RE: Fire Station No. 1 Renovation Project- Change Order No. 3:
COR 008- Lintels for Windows in Existing Walls (RFI 22)
COR 009- EMS Storage Room 140 Shoring Ceiling and Enclosure Ceiling Opening (RFI 18)
COR 003- P-3 Walls on South and East Walls of Training Room 001
COR 011- Stair 1 Wall Height (RFI 20)
COR 002- Lav Shields in Place of Lav Guards on P3 Fixtures
COR 007- Shower Bases (RFI 17)
COR 010- Floor Sink in Basement Mechanical Room (RFI 23)

Change Order

Project: Jackson Fire Station #1 Building Addition and Renovations	Owner: City of Jackson	Owner's Contract No.: 24-35
Contract: General Contract		Date of Contract: 04/02/2024
Contractor: Penzel Construction Company, Inc.		Engineer's Project No.: 22-273

Subject:
Window Header in Existing Walls

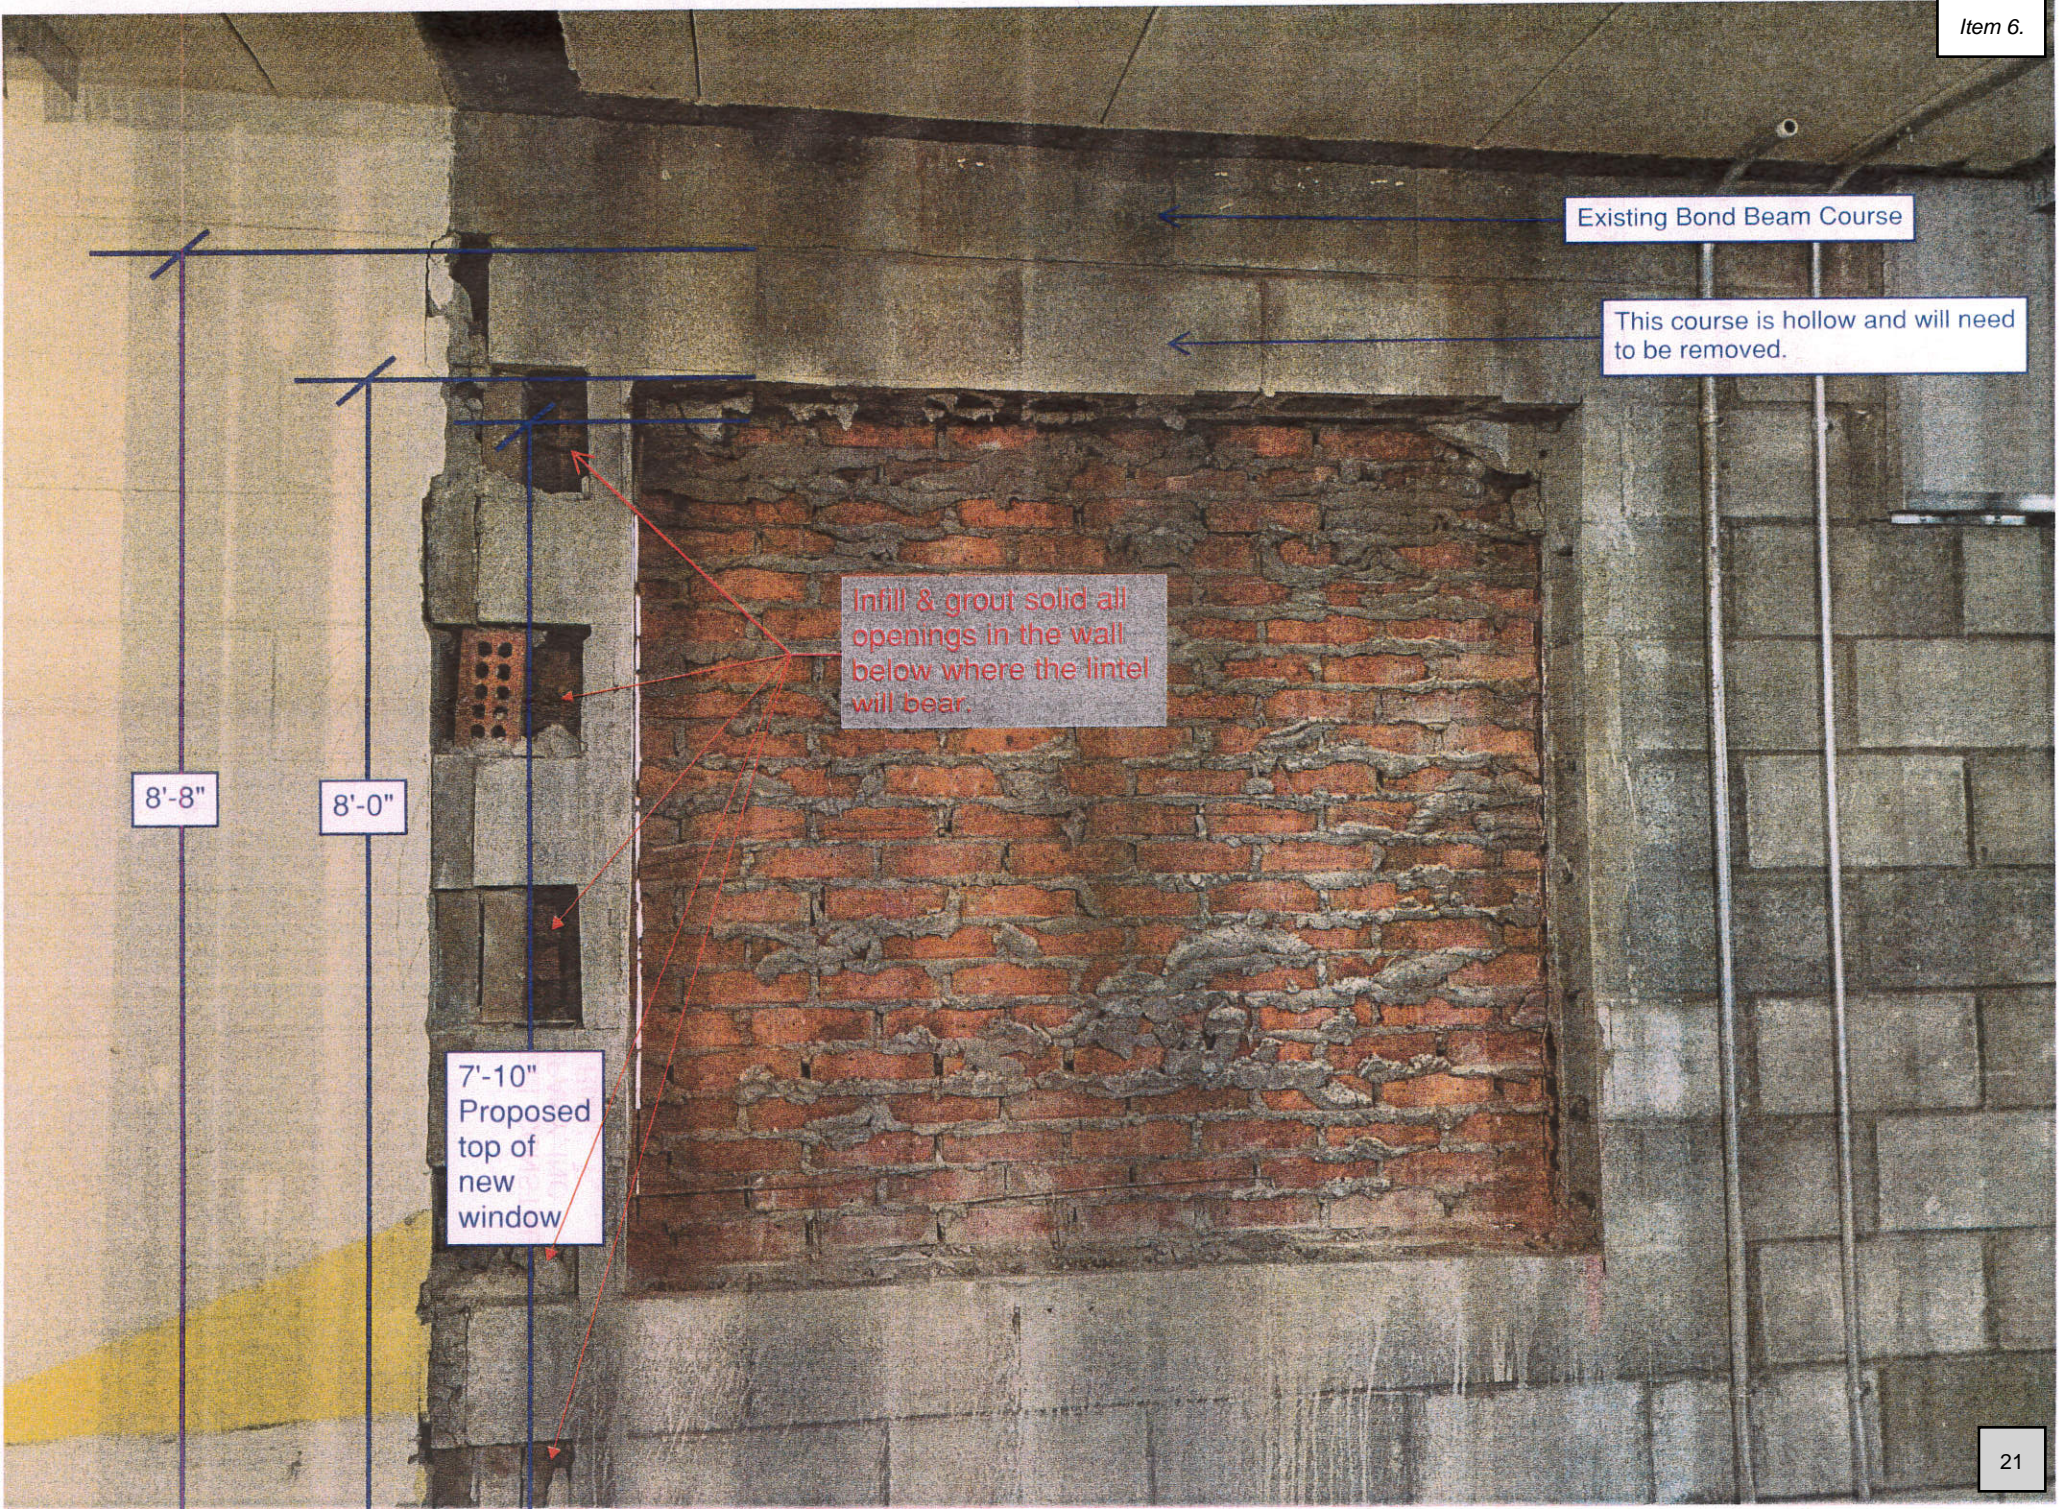
Please reference Window Head Detail (Existing Wall) 14/A3.4. This detail shows an existing CMU bond beam at the top of the new window. Drawing A2.1 shows the top of the windows to be at 7'-10" above the floor. While demoing the new openings, it was found that the existing CMU bond beam is roughly 8'-8" above the floor, which is 10" higher than the proposed top of window. Please see attached picture of a new opening onsite with added comments. There are no steel lintels called out on the drawings for these openings either. Please advise how this 10" gap between the bottom of the bond beam and the top of the window should be infilled.

Please note that the Pella windows have already been made and are sitting in the installer's warehouse.

For the steel lintels for the new window openings in the existing 6" CMU block walls of the office building use the following:

- (2) L 2 ½ x 2 ½ x 5/16 angles back to back (window width 5'-0" – window type C)
- (2) L 2 ½ x 2 ½ x 1/4 angles back to back (window width 3'-4" or smaller – window types A, B, & D)

The pair of steel lintels can be connected bolted @ 32" o.c. per the cover sheet instructions or welded (1" per 12" of angle) and the angles can be painted with galvanized paint.

BASEMENT FLOOR PLAN

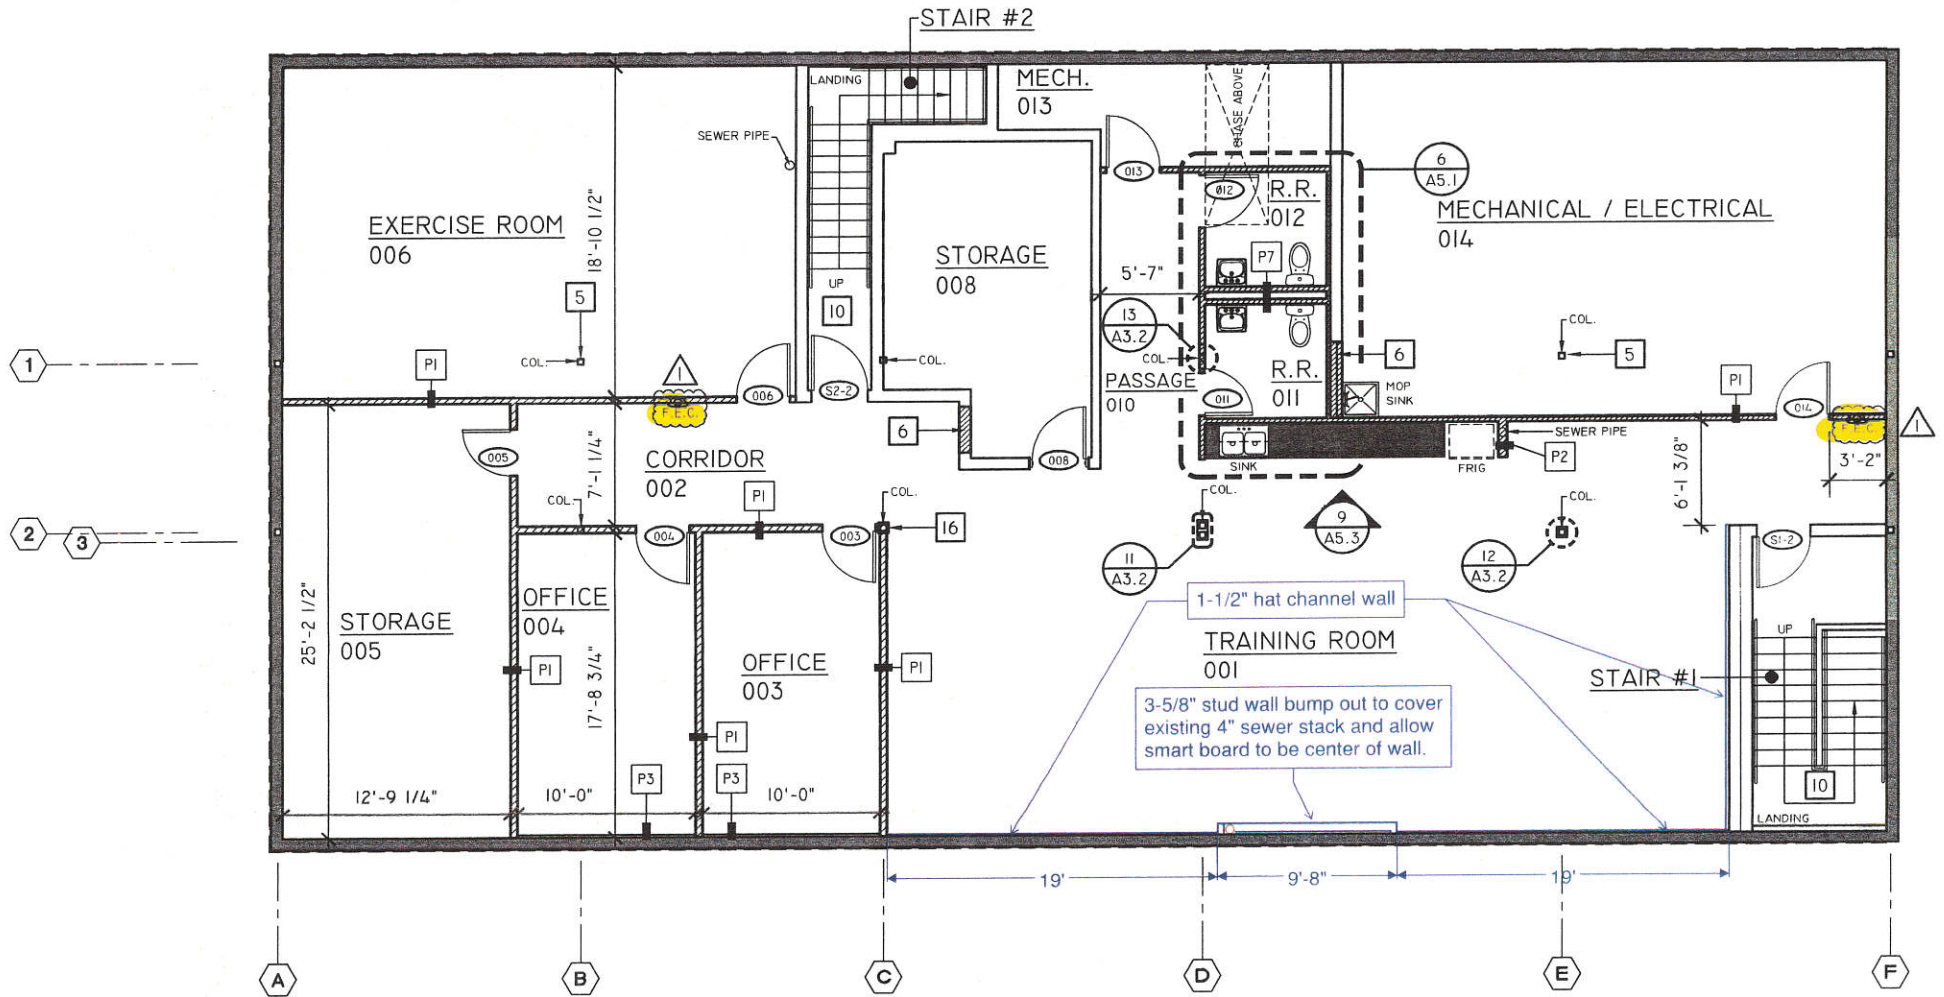
Floor plan drawing A1.1 does not call out for the South and East walls of Training Room 001 to be furred out with drywall, but the finish schedule on A4.1 calls out for these walls to be painted drywall. After a site visit it was determined there is also a 4" sewer stack that needs to be covered on the South wall. Penzel plans to install a 3-5/8" stud wall bump out to cover this sewer stack and allow the smart board to be installed in the center of the room. The remaining South and East walls of this room will be furred out with 1-1/2" hat channel. See attached sketch showing the proposed plan. Penzel requests to be compensated for this change in scope in the amount of \$3,261.72.

LAV SHIELD®
LAVATORY PROTECTIVE ENCLOSURES

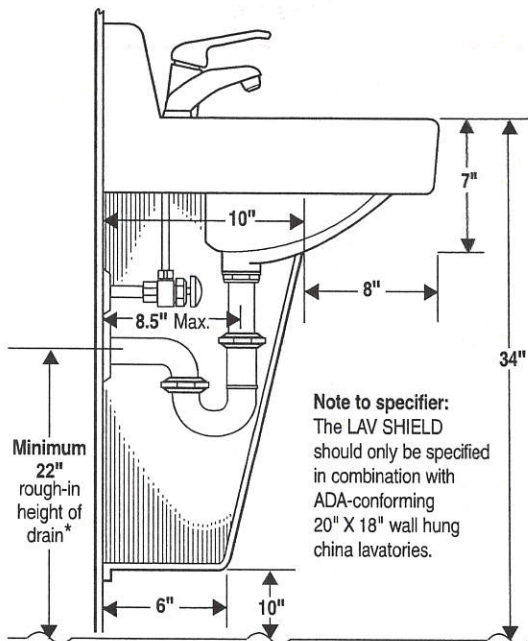
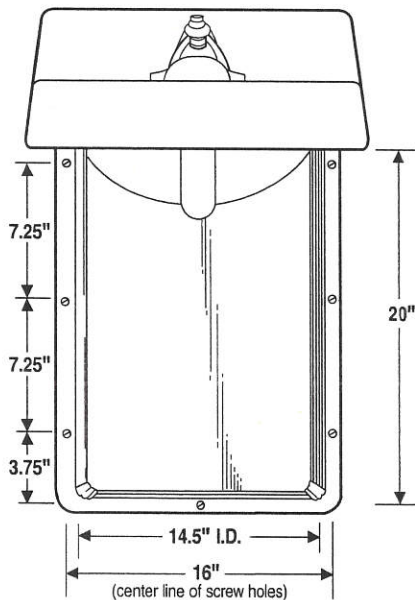
Per response to the plumbing fixtures submittal review comments, Lav Shields are required to be used on the (7) EA - P3 fixtures in lieu of the specified Lav Guards. Penzel Construction Company requests to be compensated for this change in scope in the amount of \$1,715.70.

Provide Lav Shields for seven P3 fixtures in lieu of specified lav guards. Lav shield cut sheet attached.
